RE: Great River Energy – Proposed 230-kV Transmission Line Reroute

RE: Case No. PU-12-398 – Great River Energy 230 kV Transmission Line
Grand Forks – Devils Lake Reroute
Late Filed Exhibit 10 - “Guide for Cutting Off Existing Pole (GD Line, Structure
Abandonment)”

GUIDE FOR CUTTING OFF EXISTING POLE
(GD LINE, STRUCTURE ABANDONMENT)

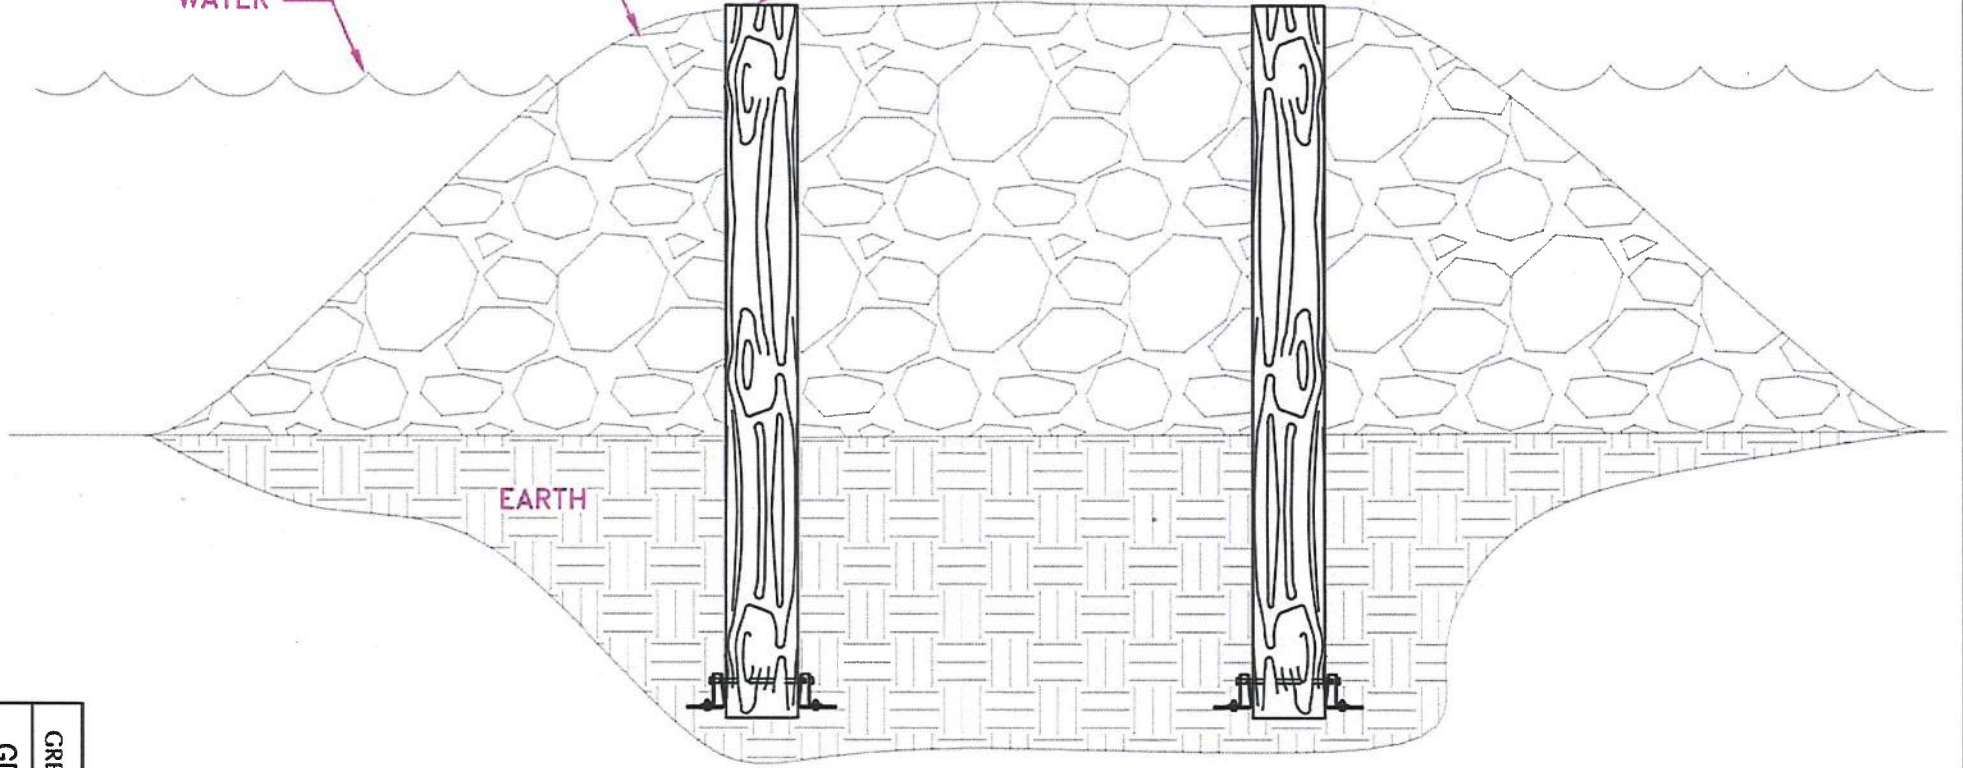
I called Brian in response to the 7/26/12 letter from Greg Link to confirm the requirements for the special use permit to abandon transmission line poles within the Crary Wildlife Management Area.

Brian said we should pull the poles, but leave the rock piles. Since our activities would occur in the winter on ice over the flooded WMA, we did not need the permit.

As discussed during the public hearing on the above-referenced case, please find enclosed for filing a drawing titled the “Guide for Cutting Off Existing Pole (GD Line, Structure Abandonment).” This drawing is designated as Exhibit 10. It depicts the method of abandonment of the existing transmission structures that are in flooded locations and intended to be relocated as part of the proposed project.
